## REVISION TRANSMITTAL SHEET

### INSPECTION – WING REAR SPAR AND FLAP/AILERON HINGE BRACKETS

<b>Service Bulletin No.: V2/0009</b>	<b>Date of Original Issue: 26 Jul 2016</b>
<b>Revision No: Revision A</b>	<b>Date of Issue: February 10, 2017</b>

NUMBER: V2/0009

FIGURE 1

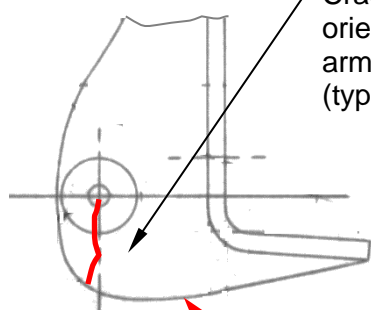
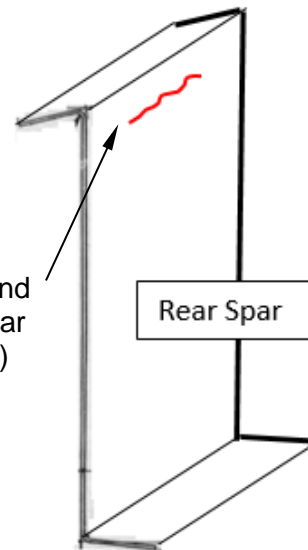
3. Remove the wing tip.
4. Using a borescope with a flexible cable hooked to the camera head (and aid tools as required to maneuver the borescope camera head) through the access openings indicated in Paragraph II.A.1 to II.A.3, visually inspect the rear spar for cracks, buckles, wrinkles, ripples, or other damage at WS 1.25, 56.0, 123.5, 137.0, 191.0 and 246.0 where the aileron and flap hinges are attached. Pay particular attention for typical crack location and orientation, as shown in Figure 1.

6. With the aid of strong light and minimum 10X magnifier glass, visually inspect all aileron/flap hinge arm support brackets for cracking at lower attachment fastener hole (on both flanges) at WS 1.25, 56.0, 123.5, 137.0, 191.0 and 246.0:
